**PROPOSED RESPONSES TO THE USEPA COMMENTS ON FINAL
REPORT FOR REMOVAL ACTION 14**

DOE-0513-95
DOE-FN EPAS
35
RESPONSES

ATTACHMENT 1
Comment Disposition Record
Contaminated Soils Adjacent to the Sewage Treatment Plant Incinerator
Removal Action No. 14 - Final Report

Figure 2-4. On-Property Soil Excavations.

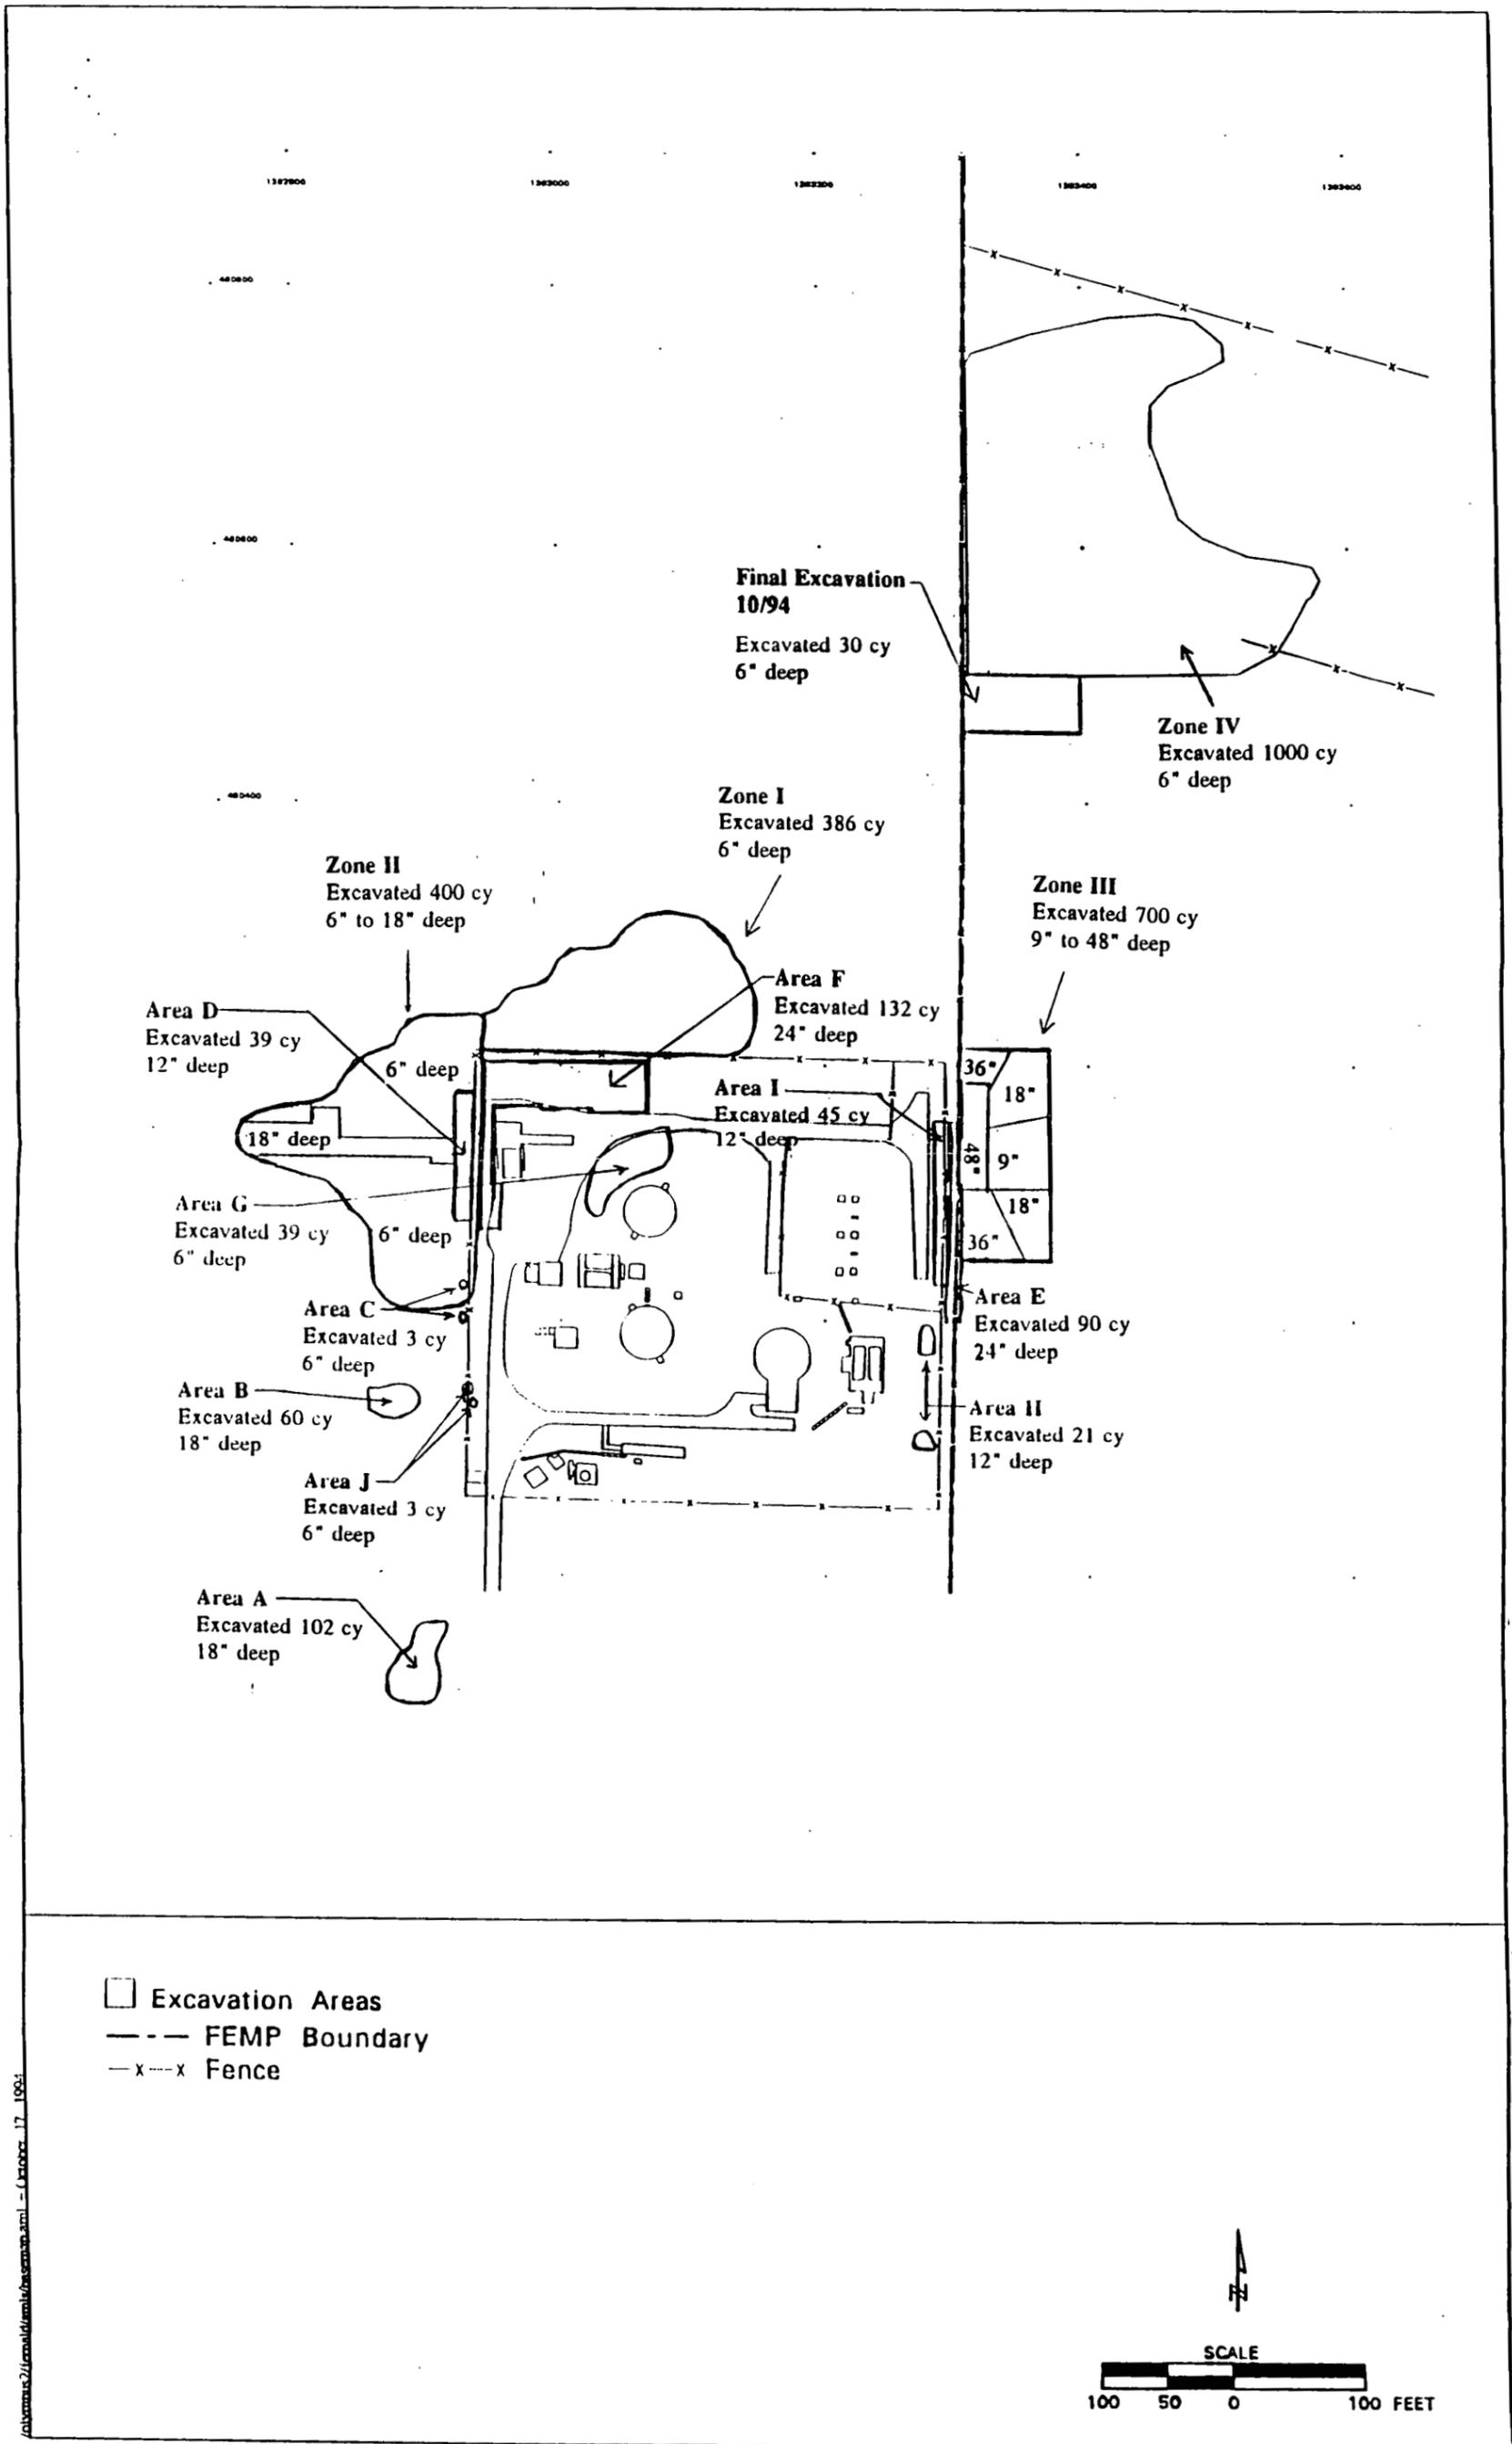
The information regarding the maximum depth of excavation and aerial distribution of deep and shallow zones of excavation is not presented in this section (on-property actions) or in Section 2.3.2 (off-property actions). This information should be included in the text. Information regarding the volume and vertical distribution of the clean fill at the site should also be included. The vertical profiles should be constructed to supplement the information presented in Figure 2-5, which shows the final excavation areas with verification sample point locations.

In addition, Figure 2-4 has been revised to include the depths and volumes of soil excavated from both on-property and off-property areas. Figure 2-5 was not used because of the dense configuration of the verification sample points.

Figure A-2. Total uranium calibration curve for radiation survey instruments at FEMP.

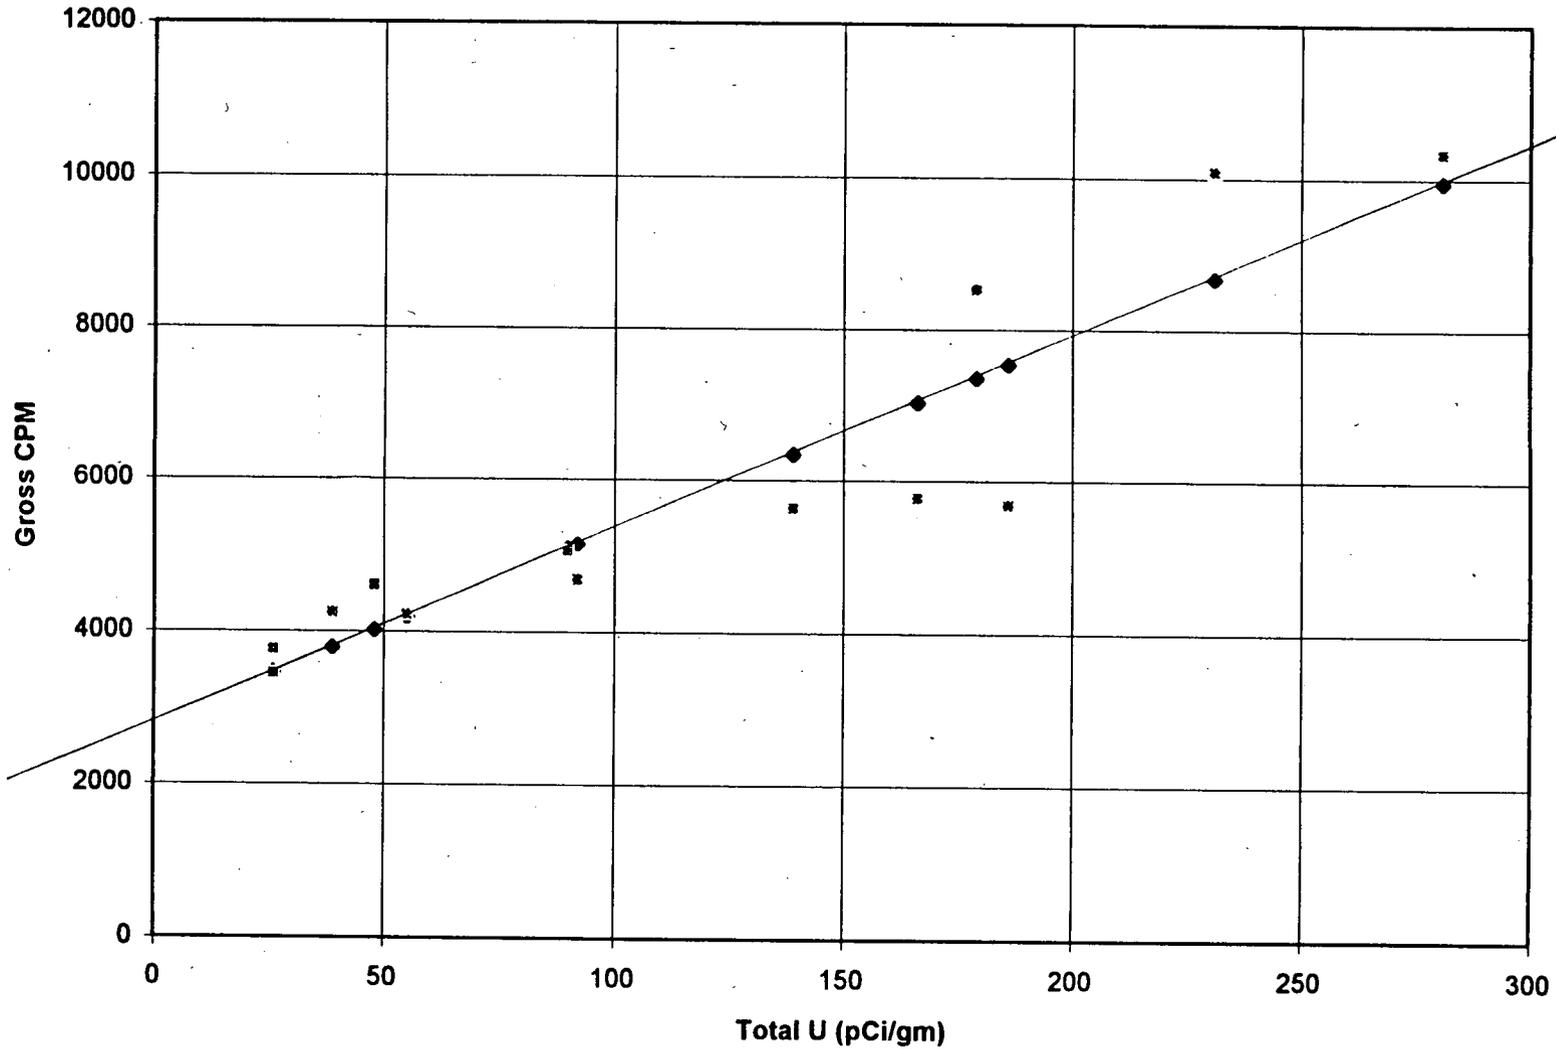
The rationale for excluding eight data points from the correlation is not clearly presented and should be justified by additional discussion. Also, similar to specific comment 3, the discrepancy between the text in this paragraph and Figure A-2 should be corrected. The note explaining which points were excluded from the revised correlation curve should be added to Figure A-2.

The text in Section 2.1.2, page 2-7, and Table A-1 in Attachment A have been changed to explain the rationale for excluding data points, No. 1, 2, 3, 6, 7, 10, 15, and 18.

CAUSED FALSE READINGS IN THE NAI DETECTOR. Based on examination of these data, it was determined that points 1, 2, 3, 6, 7, 10, 15, and 18 should be excluded from the correlation. The revised correlation, with these 8 points excluded, is presented in Attachment A, Figure A-2."

In addition, the discrepancy between the text and Figure A-2 in Attachment A has been resolved to include reference to all eight data points.

The definition for Y should be added to the figure legend.

In Attachment A, Figure A-2, the term "Y" has been omitted. The legend has been revised to provide definitions for the "asterisk" as the **Measured** Counts Per Minute (CPM) and the "diamond" as the **Predicted** CPM.
